STATE OF CONNECTICUT  
CONNECTICUT SITING COUNCIL

IN RE: :  
: :  
APPLICATION OF NTE CONNECTICUT, LLC : DOCKET NO. 470B  
FOR A CERTIFICATE OF ENVIRONMENTAL :  
COMPATIBILITY AND PUBLIC NEED FOR :  
THE CONSTRUCTION, MAINTENANCE AND :  
OPERATION OF AN ELECTRIC POWER :  
GENERATING FACILITY OFF LAKE ROAD, :  
KILLINGLY, CONNECTICUT : MARCH 15, 2019

**RESPONSES OF NTE CONNECTICUT, LLC  
TO CONNECTICUT SITING COUNCIL INTERROGATORIES, SET ONE**

On February 22, 2019, the Connecticut Siting Council (“Council”) issued Interrogatories to NTE Connecticut, LLC (“NTE”), relating to Docket No. 470B. Below are NTE’s responses.

# **ATTACHMENT 3**

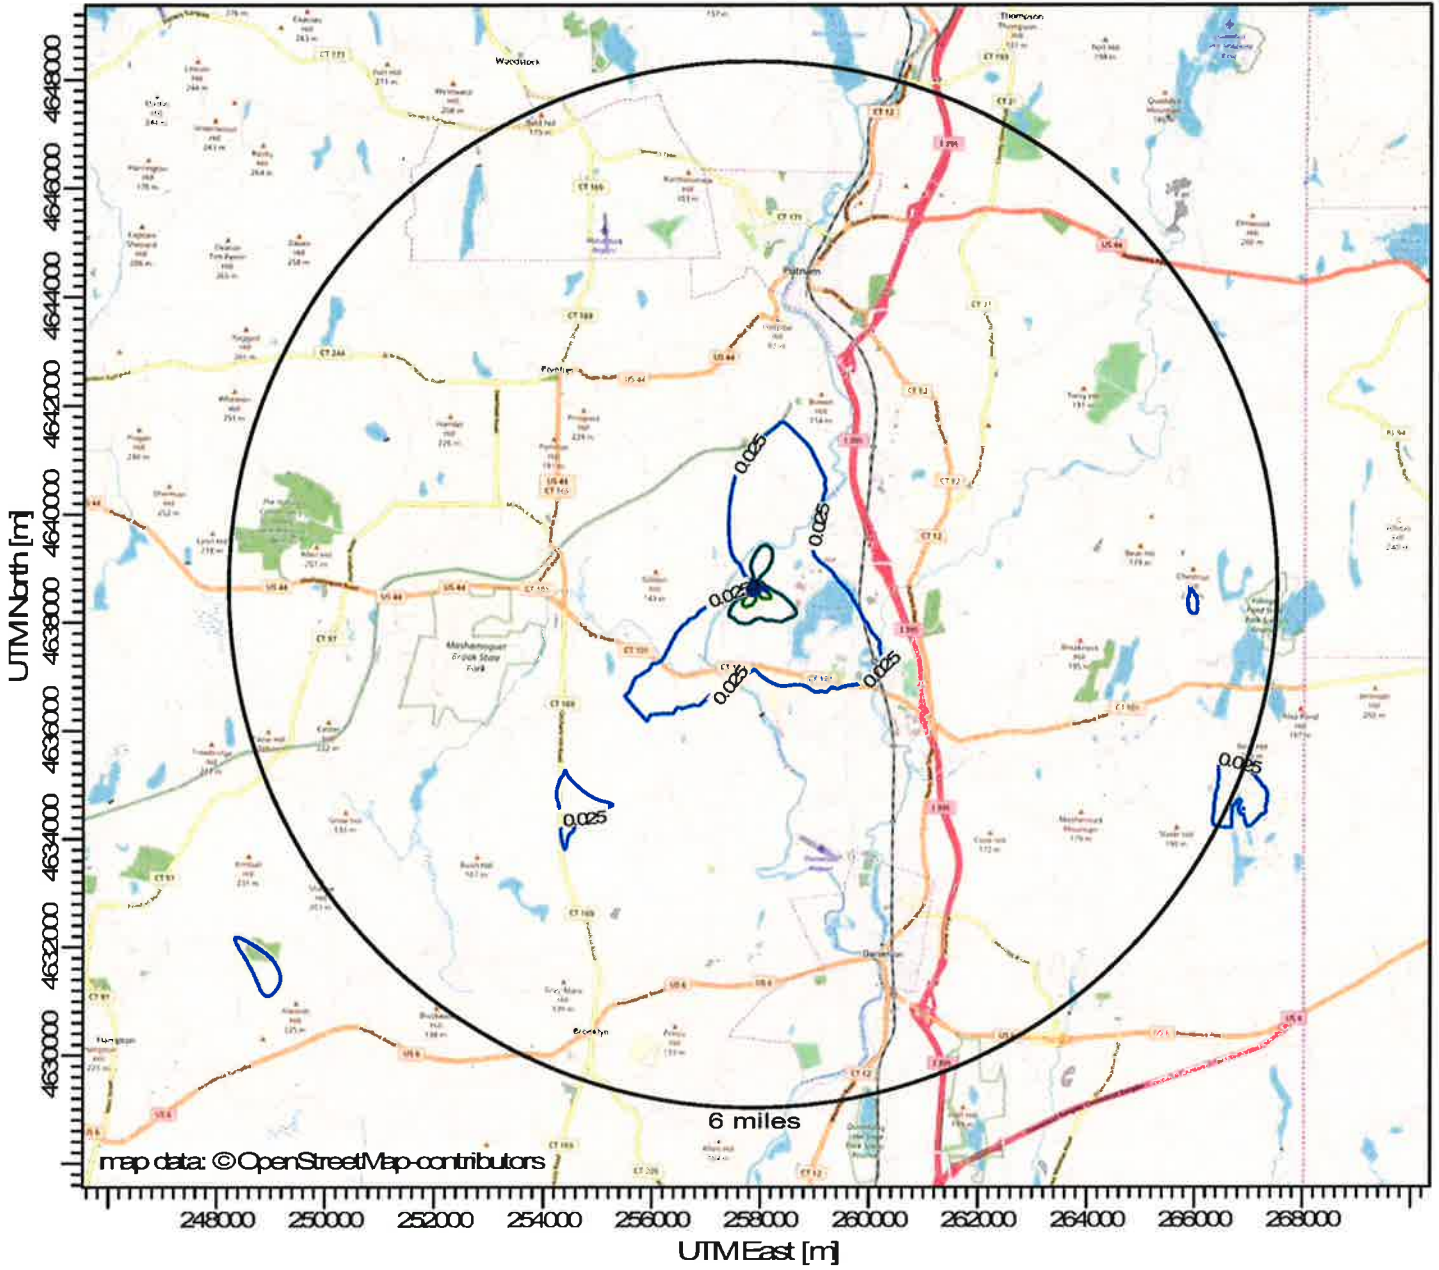
Provide an updated KEC Water Balance, similar to Figure 2-11a through 2-11b of the original Application. If this document is not materially changed due to the proposed 650 MW configuration, please indicate as such.

The updated KEC Water Balance requested is included at Attachment 3. As expected, the updated Water Balance does show certain increased values in the Summary Flow Table. Given the increase in power output at KEC, from 550 MW to 650 MW, these water balance increases are not material and remain within the previously stated maximum values. NTE was able to achieve some significant decreases in the levels of waste water discharges to the Town's sewer system when running on ULSD.

# **ATTACHMENT 6**

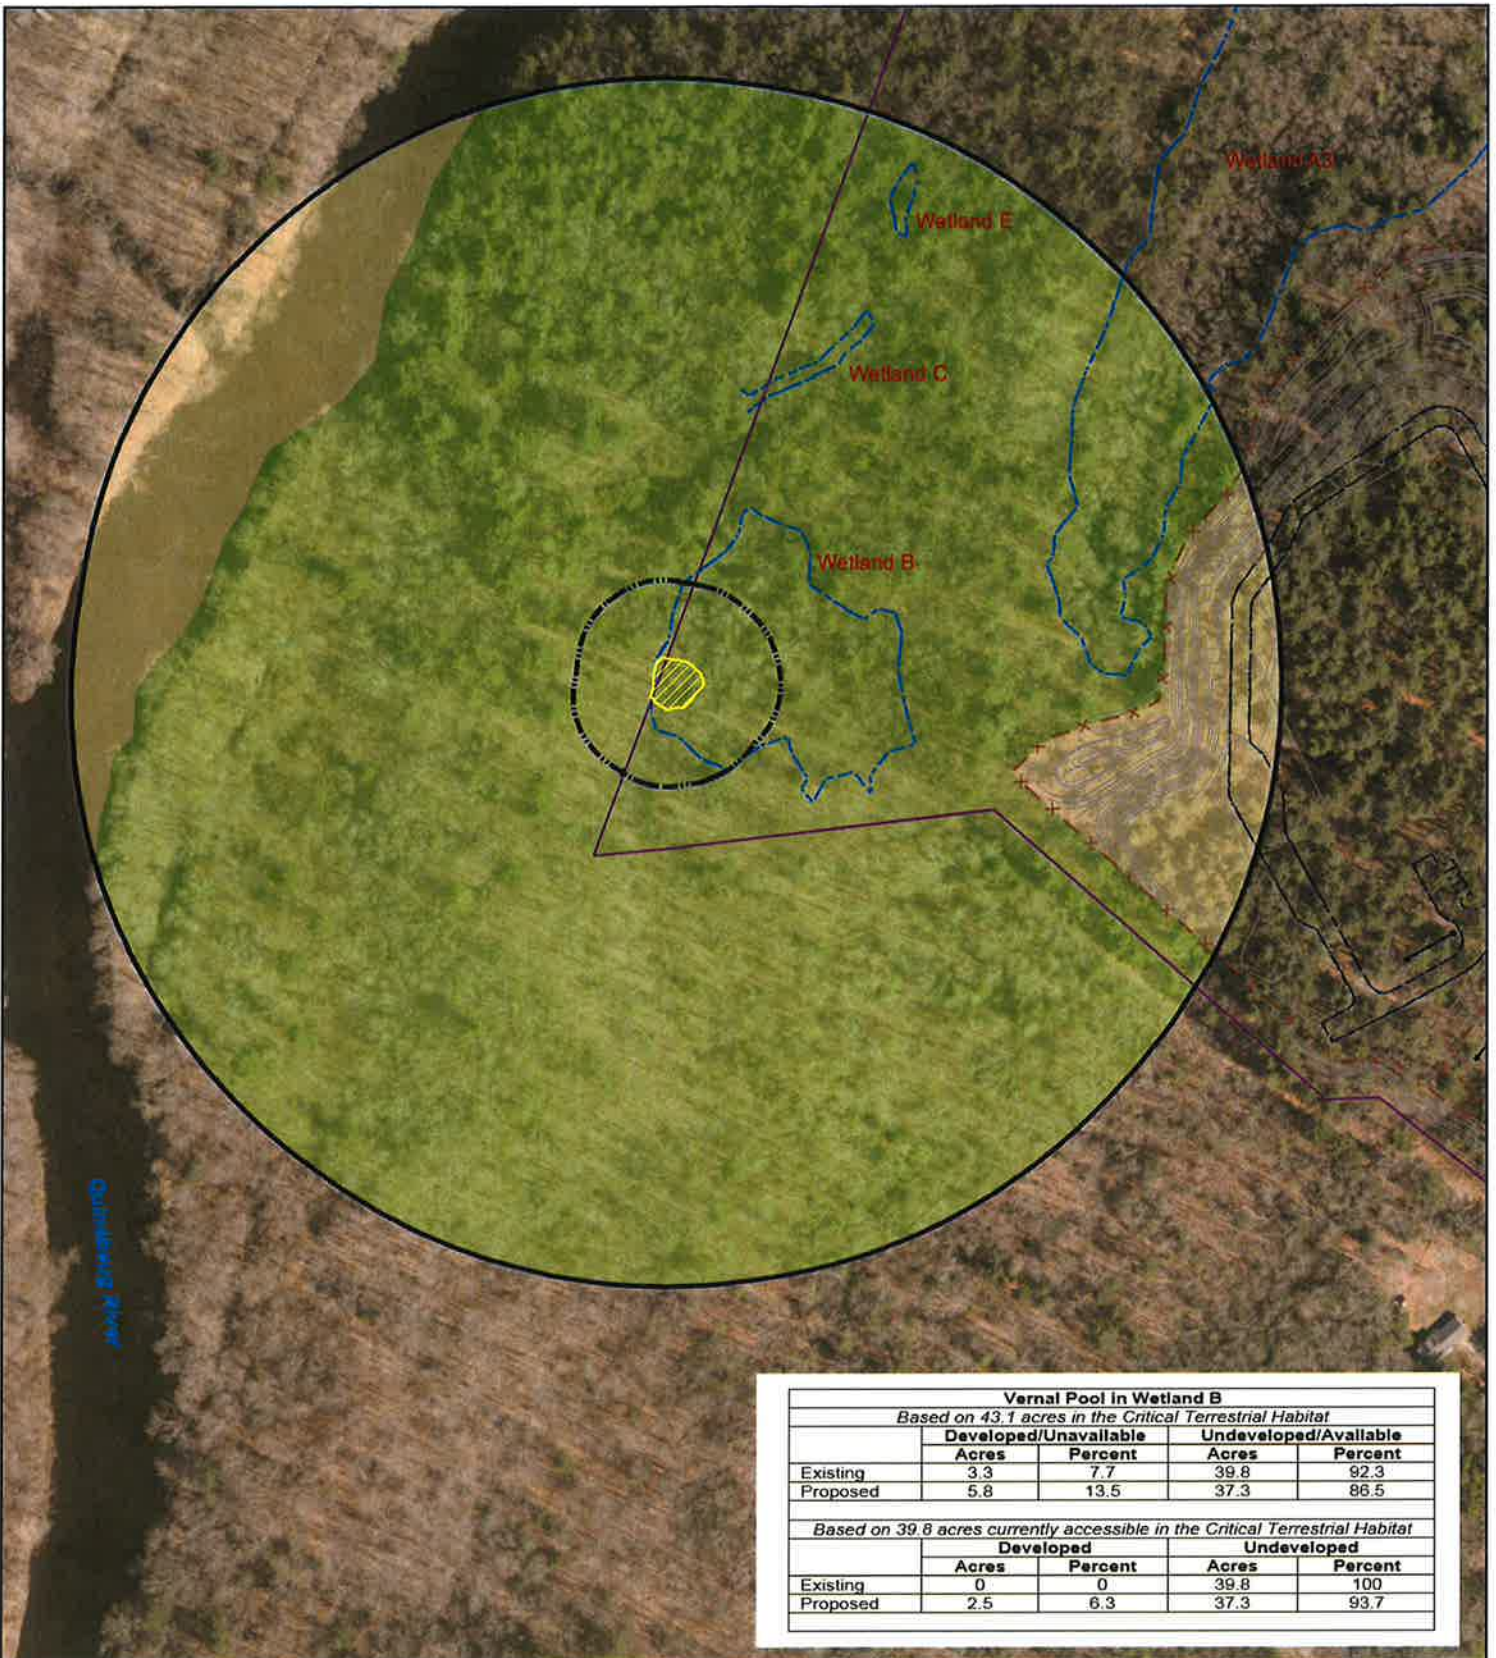
Referencing FOF #453 through #458, would development of the proposed project not occur closer than 430 feet from the edge of the vernal pool habitat in Wetland B? If no, please revise that number accordingly. Also, please update the numbers from FOF #458 relative to the Critical Terrestrial Habitat, as necessary/applicable.

No change has occurred to KEC's footprint in this area and, therefore, the CTH values remain the same. KEC-related grading is greater than 430 feet from the vernal pool within Wetland B, and the fence (now proposed along the toe of the slope) can also be placed to maintain a 430-foot separation. The figure included in Attachments 6 reflects the currently proposed conditions. The numbers remain the same as those filed in support of Response 1 of NTE Exhibit No. 21, dated November 28, 2016. The numbers referenced in FOF #458 are those that appear in NTE's Exhibit No. 7, Set 1 interrogatory responses dated October 7, 2016. The numbers in NTE Exhibit No. 7 were updated in NTE Exhibit No. 21. Both responses reflect similar impact levels.

# Calculated Magnetic Field Levels

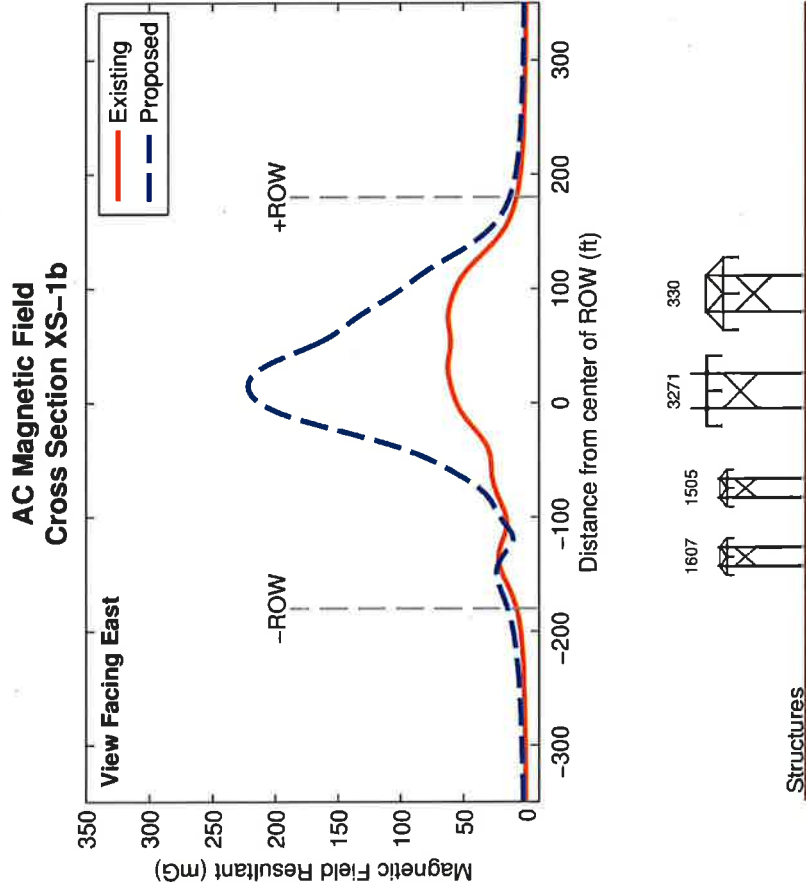
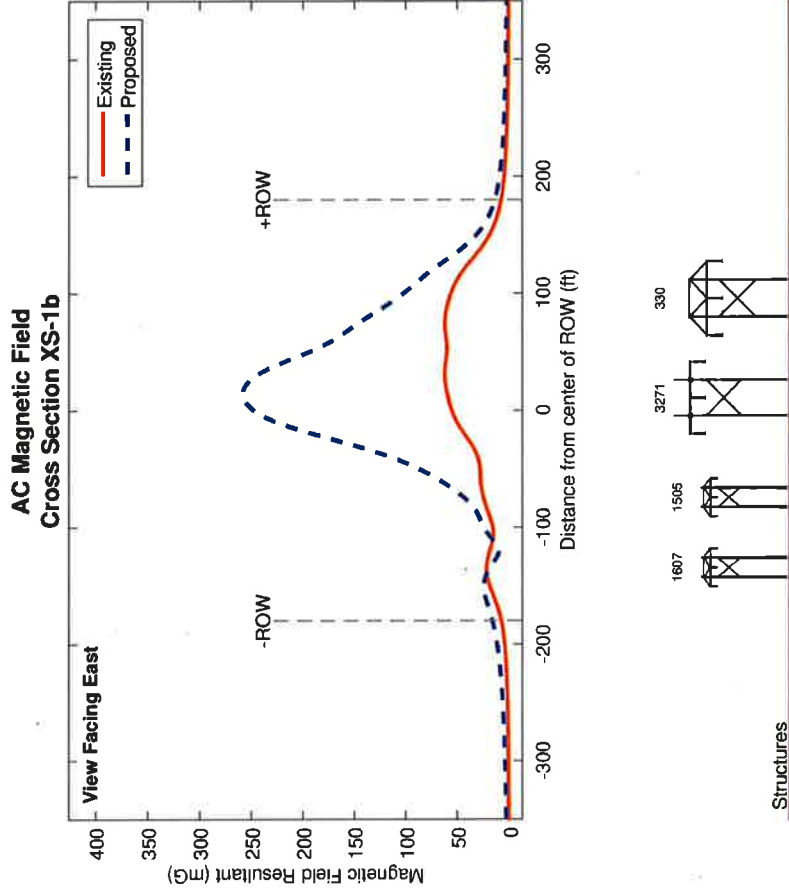
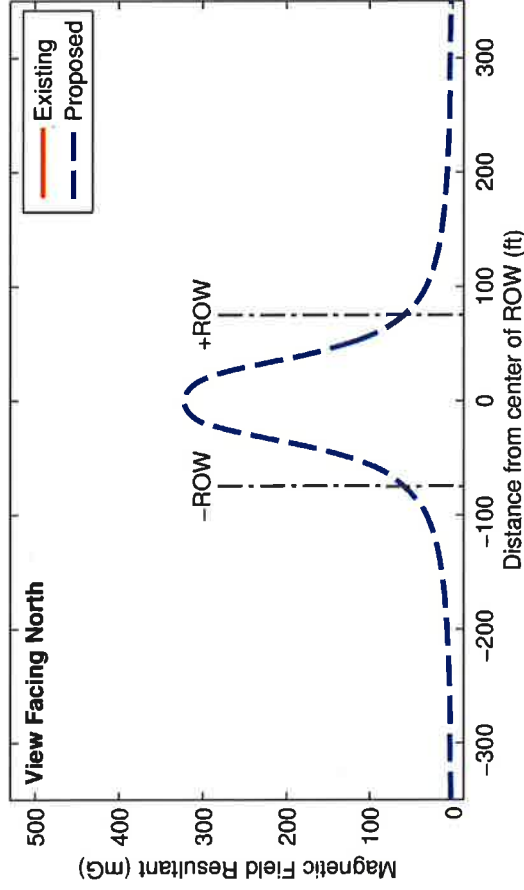
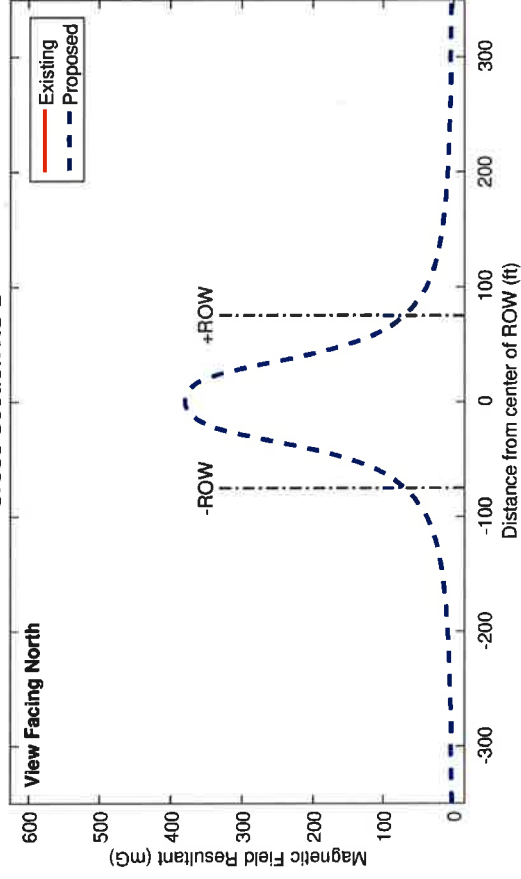
Referencing FOF #347, would the maximum magnetic field level (under average annual load conditions) of 213 mG in the center of the electric transmission right-of-way adjacent to the proposed Utility Switchyard be materially affected by the change from 550 MW to 650 MW? If yes, estimate the updated maximum mG.

The magnetic field level in the center of the transmission line right-of-way adjacent to the proposed Utility Switchyard is calculated to be 249 mG, decreasing to a level of 16 mG or less at the edge of the right-of-way. The maximum magnetic field on the right-of-way is 258 mG, beneath the 345-kV transmission line. Although the additional power flow on the transmission line will increase the magnetic field levels, because the transmission line serving KEC is near the center of the right-of-way, the change in magnetic field at the right-of-way edge and beyond is small.
